**ADDENDUM NO. 1**

**PROJECT TITLE:** GA Apron and Taxiway C

**DATE:** June 2, 2025

Coolidge Municipal Airport  
GA Apron and Taxiway C  
FAA AIP 3-04-0011-018-2025 (Design)  
FAA IIJA 3-04-0011-019-2025 (Design)  
Project No. AIP-01-2024  
Addendum No. 1

**BASE BID**  
SCALE: 1"=150'

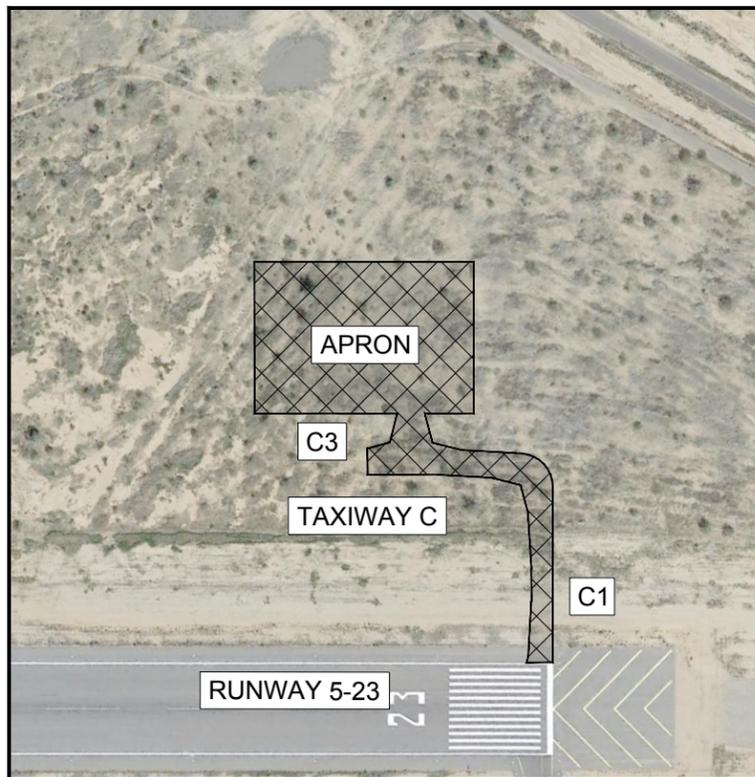
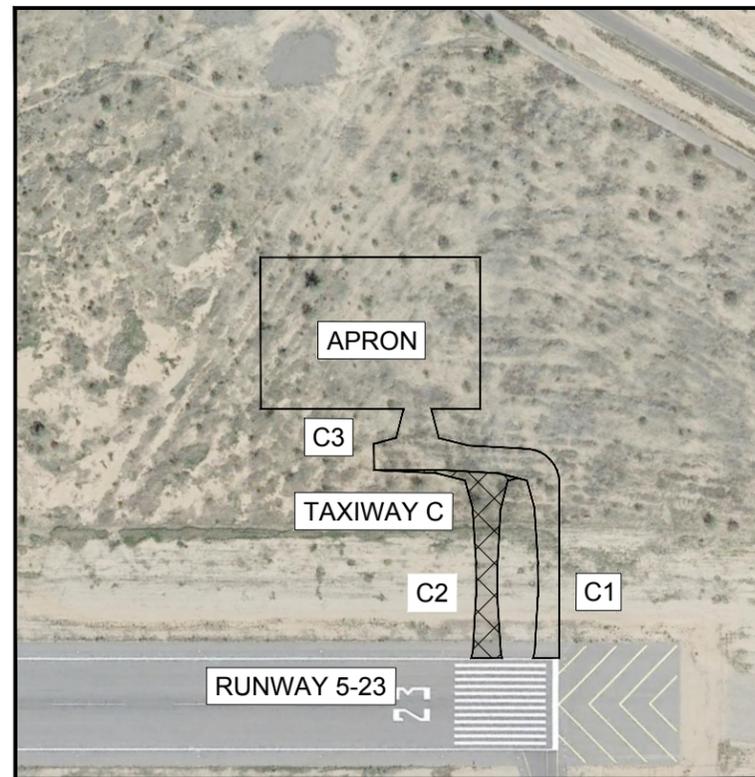
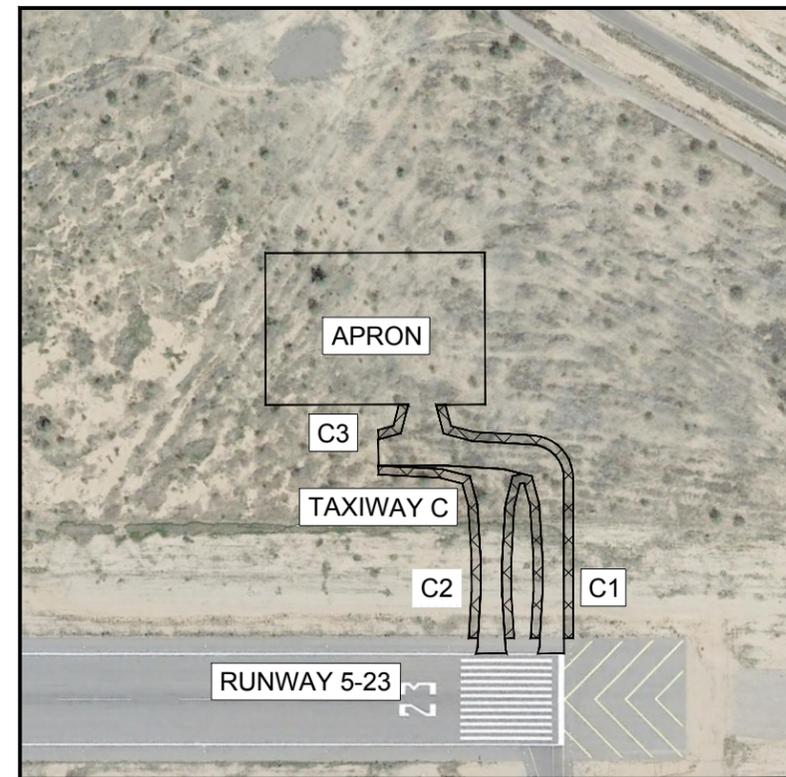
C1.3	Summary of Quantities	Updated project quantities for Base Bid, Alt 1, and Alt 2
C1.4	Project Layout	Updated Primary Control Point
C3.1	Typical Sections	Updated Subbase to P-152
C3.2	Typical Sections	Updated Subbase to P-152
C3.3	Typical Sections	Updated Subbase to P-152
C3.4	Typical Sections	Updated Subbase to P-152
C5.3	Storm Drain Details	Updated Base Course Spec Reference
E1.0	Electrical Scope of Work	Updated Alt 1 map
E1.1	Electrical Layout Plan	Updated Handhole, Sign, and Light Tables
E1.2	Electrical Layout Plan	Updated Handhole, Sign, and Light Tables
E3.2	Electrical Circuit Map	Updated Circuit Map
E2.6	Electrical Details	Added sheet and detail

**Q06** Can you confirm the RipRap quantity as the measured plan quantities do not align with the Base Bid and Alt. 1 bid quantities?

**Q14** The electrical items listed in Alternative 1 Bid appear to include the quantities also listed in the Base Bid instead of the additional quantities for the Alternative 1 Bid; what are the correct electrical quantities for Alternative 1 Bid?

**A06** Base bid RipRap quantity should equal 150 SY. Alternate 1 quantity should equal 50 SY

**A14** The corrected electrical quantities have been included in Addendum 1

**SURVEY CONTROL POINT**

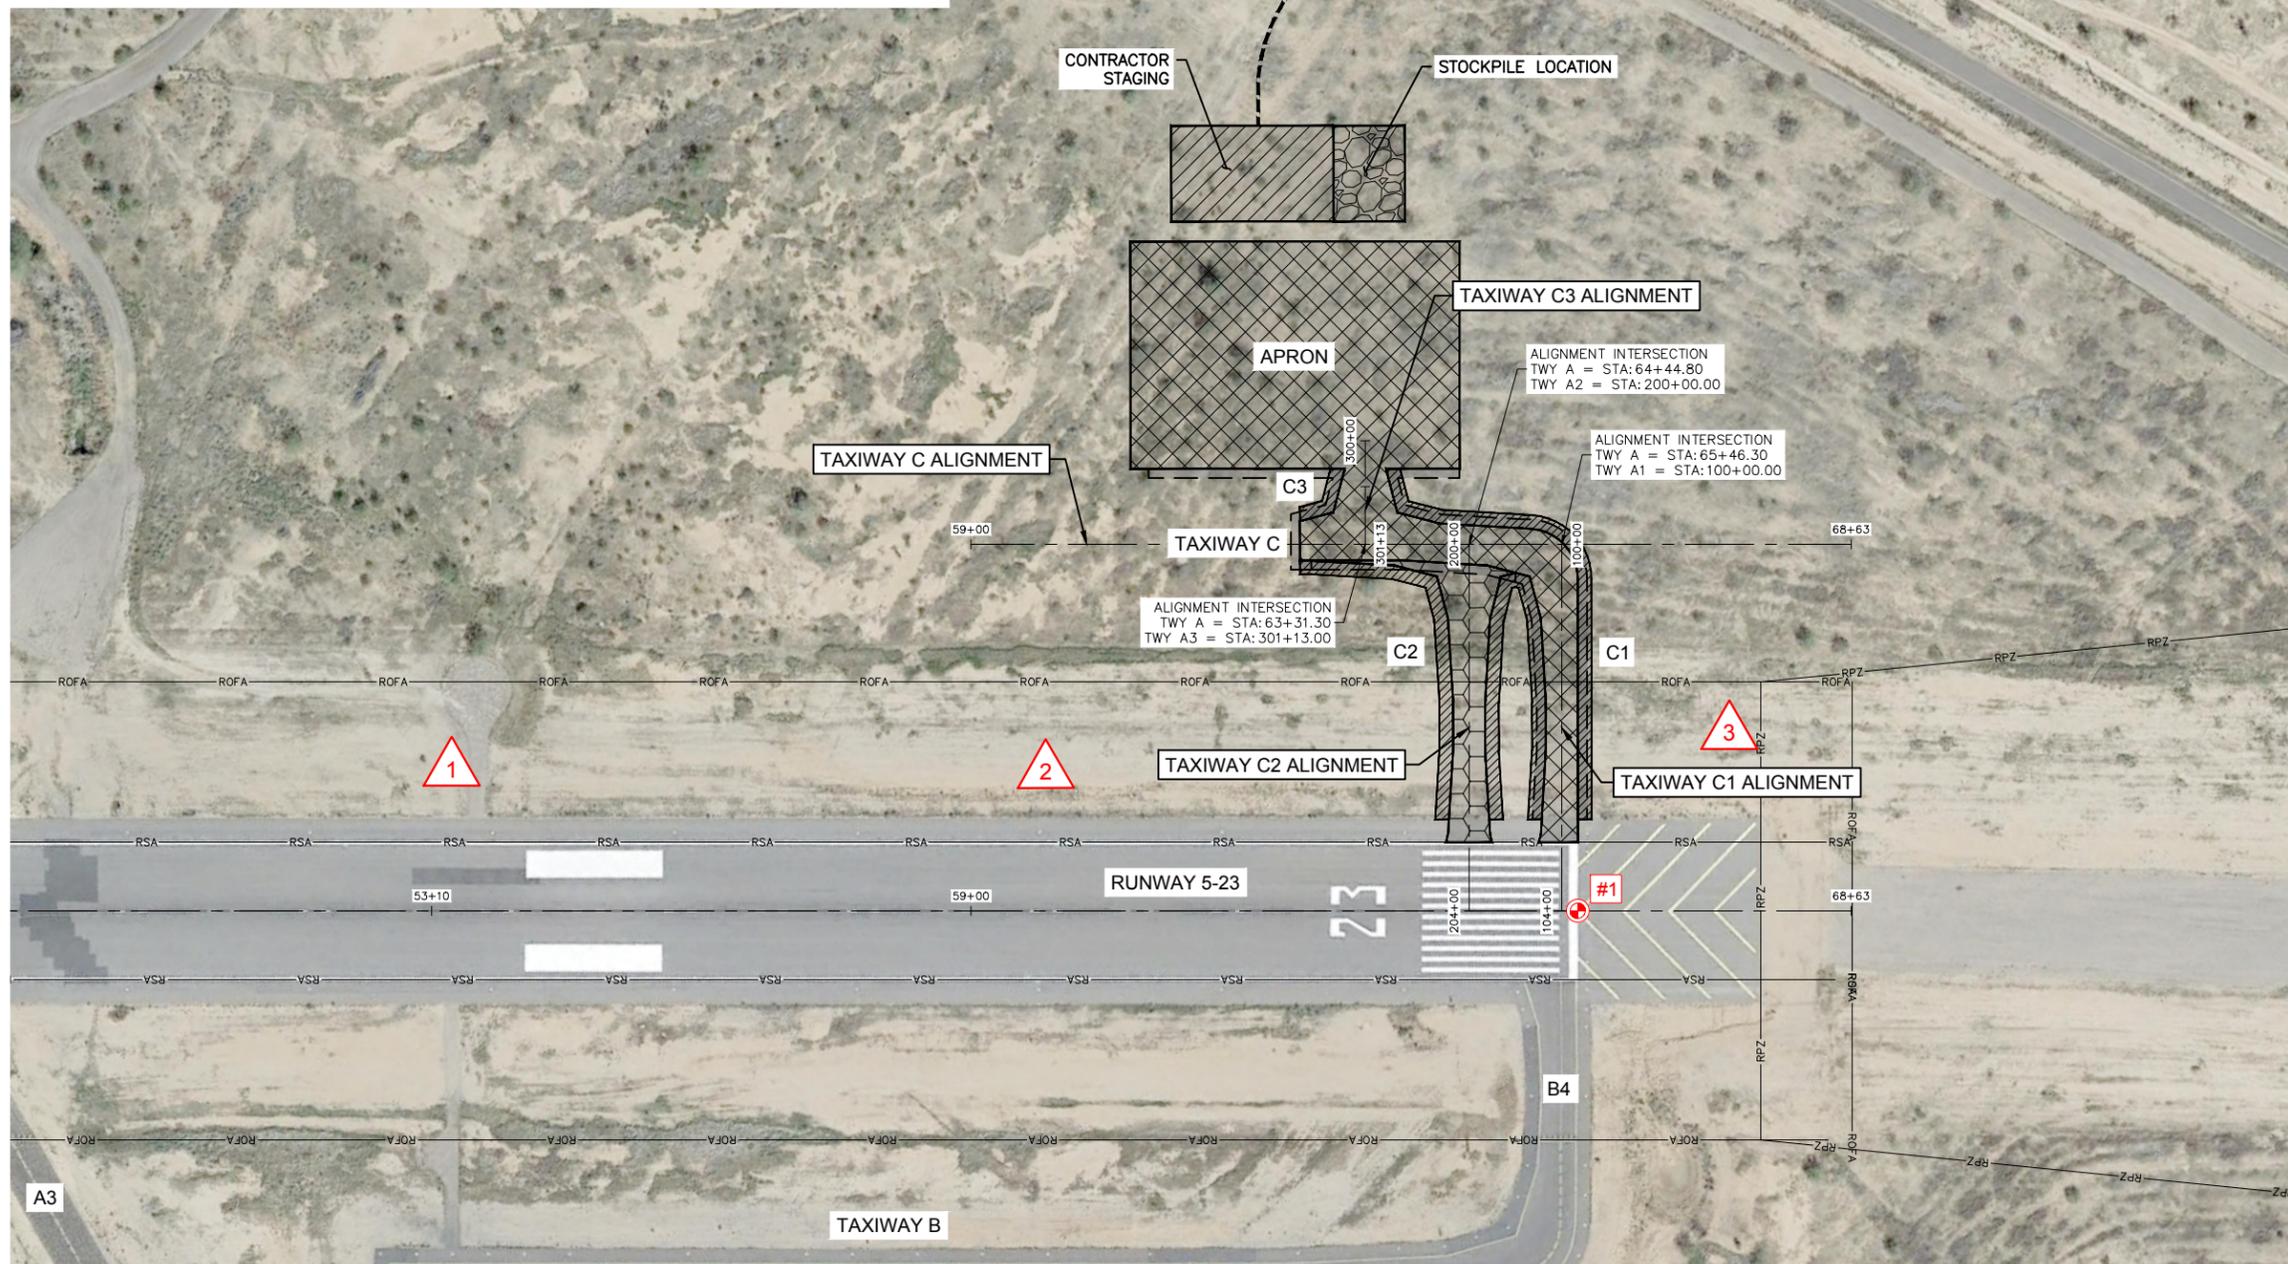
- 
- Q25** On sheet 4 of the plans the elevation for the primary control point is given as 157.99; that elevation seems incorrect as it is 1400-feet below the elevation of control point number 2. Please confirm.

- A25** The correct control point elevation is 1575.99
- 
- Q26** The drainage channel north of Taxiway C1 and the Apron seems to have a flat bottom at STA 103, but then it's a V ditch at STA 102 and is a flat bottom at STA 101. Could you please provide a cross sectional detail of the drainage channel?
